B I D A D D E N D U M 0 3

The items set forth herein, whether of omission, addition, substitution, or clarification are to be included in and form a part of the construction documents for the project listed above.

ORANGE-ULSTER BOCES
AXELROD - MAIN BUILDING ADDITIONS + ALTERATIONS
53 GIBSON ROAD
GOSHEN, NY 10924

Sheet Number
A910

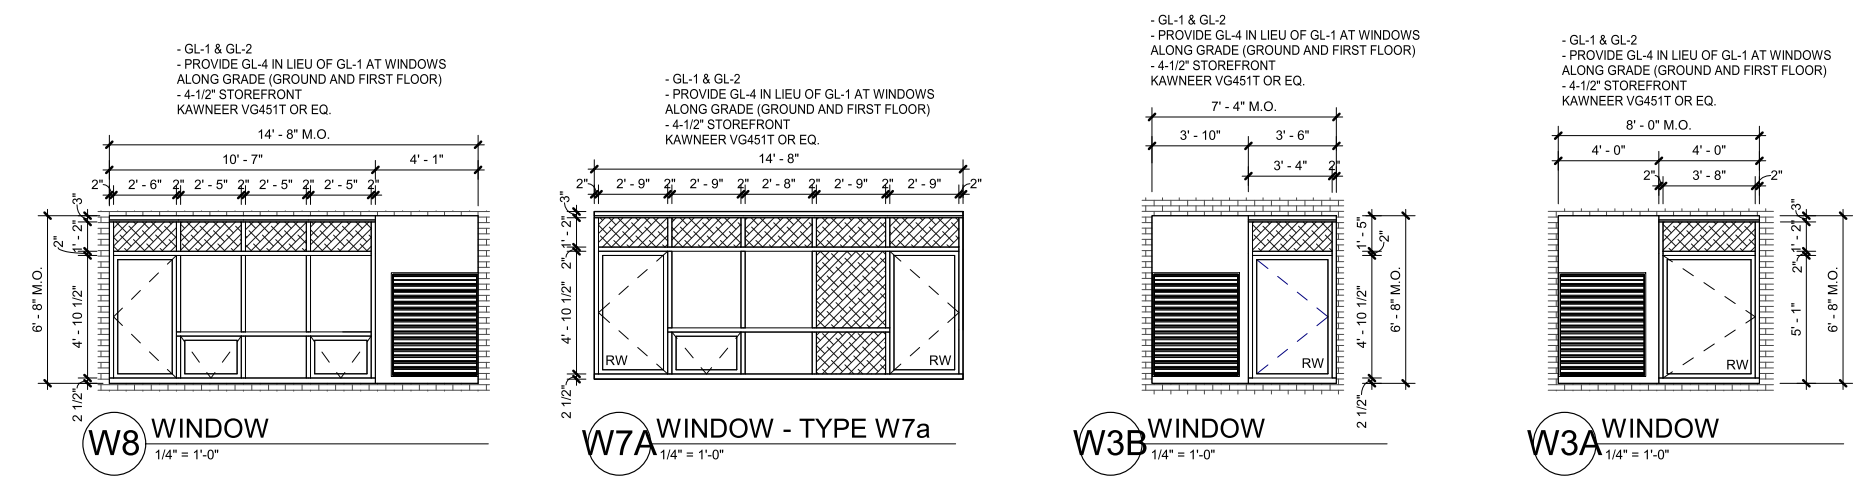
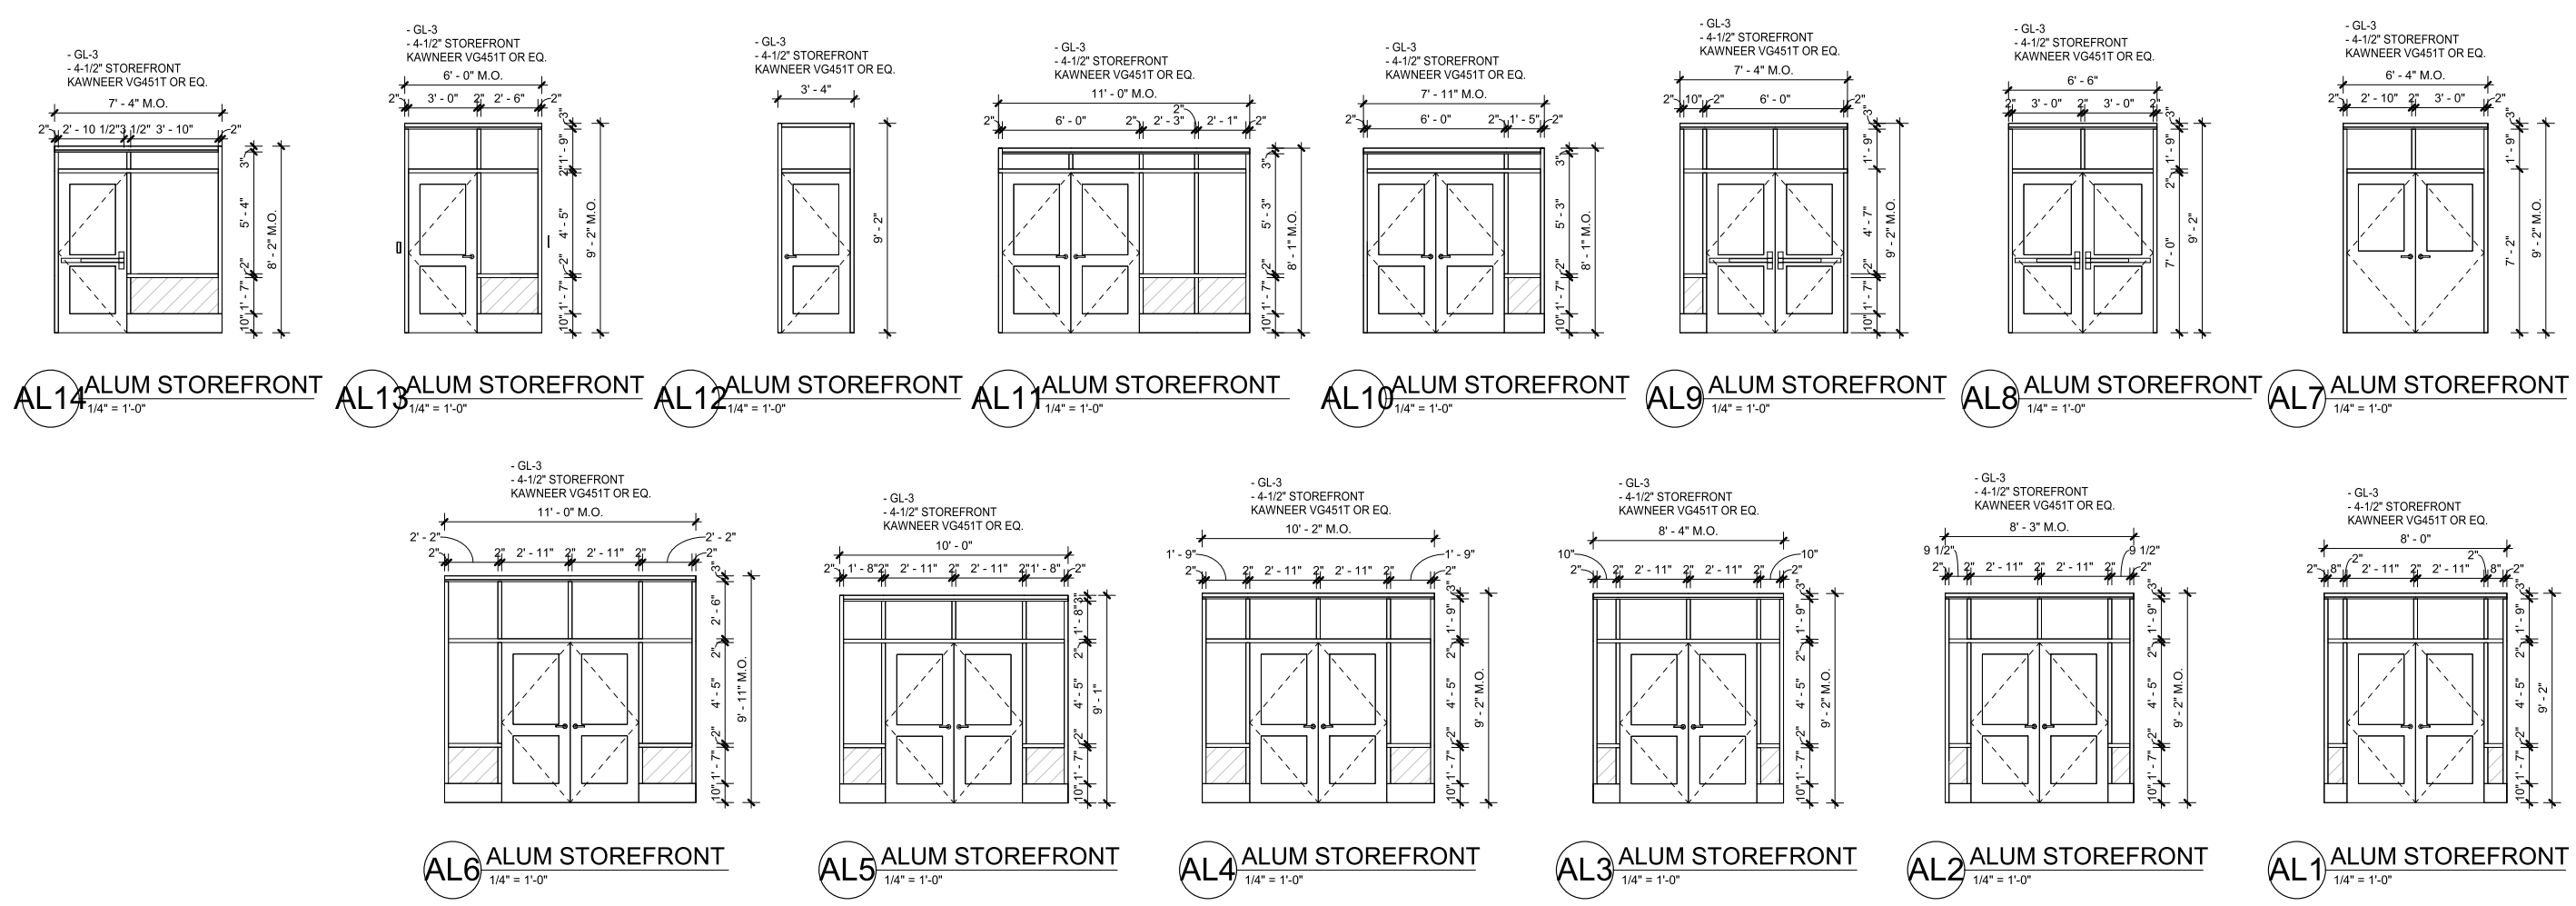
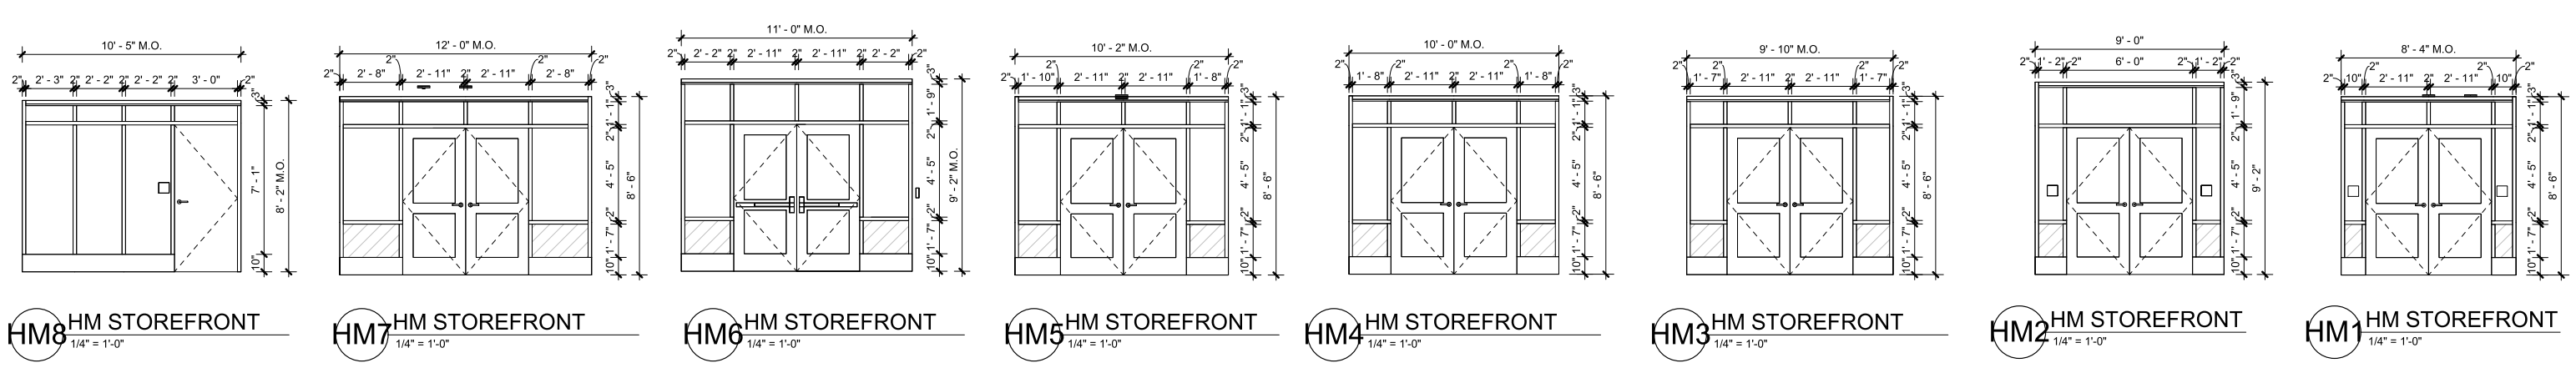
4.4 DRAWING A910 WINDOW TYPES
    a. See attached Drawing A910 – Window Types

7.18 RFI Question – Please provide elevations for doors HM4, HM5 & HM6 & HM7
RFI Response – See attached Drawing A910

Sheet Number
S101

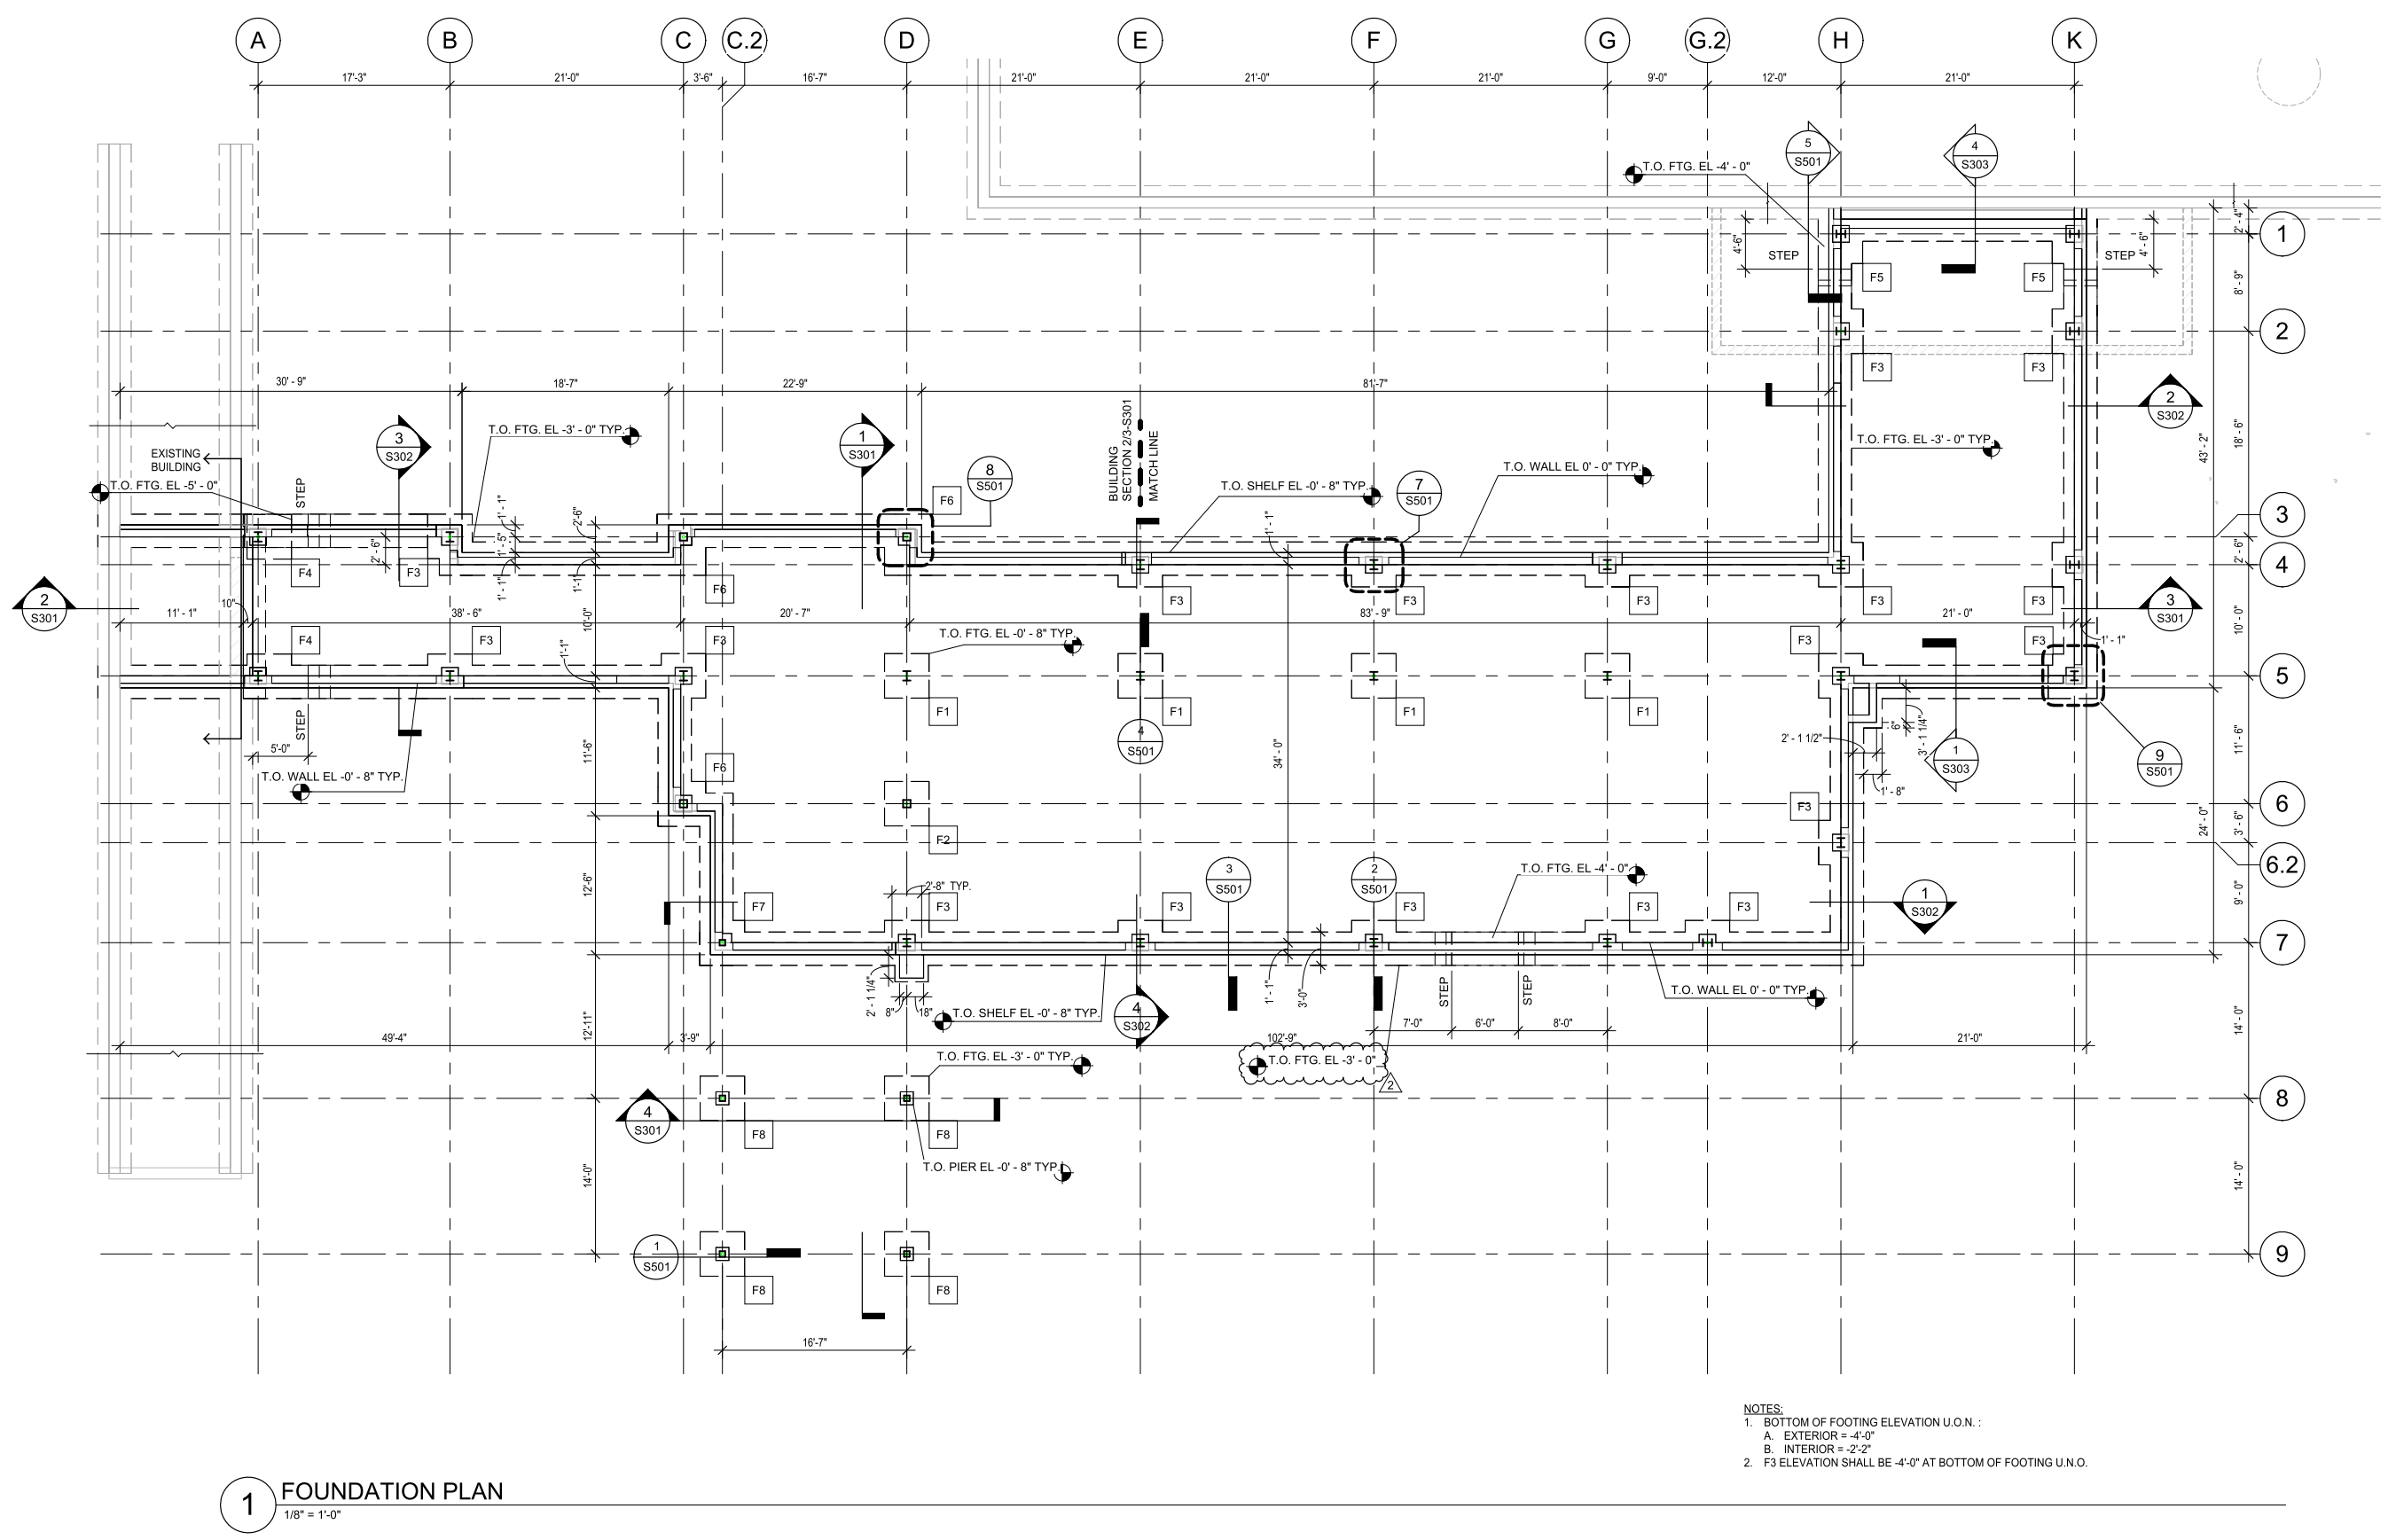
5.1 Attached please find the following revised Structural Drawings with modifications and/or additional information clouded:
Drawing S101 – New Addition Foundation Plan
Drawing S103 – New Addition Wall Framing
Drawing S105 – New Addition Clerestory Roof Framing
Drawing S106 – Part D Admin Level Floor Plan
Drawing S107 – Part A&B Roof Plan
Drawing S301 – Building Sections
Drawing S302 – Building Sections
Drawing S303 – Wall Sections
Drawing S402 – Classroom 500/508 Structural Alterations
Drawing S501 – New Addition Foundation Details
Drawing S502 – New Addition Slab Details
Drawing S503 – Structural Steel Connection Details
Drawing S504 – Open Web Joist and Cold Formed Metal Detail
Drawing S953 – Pool Infill at Life Skills Rm 250 (Add-Alt #3)
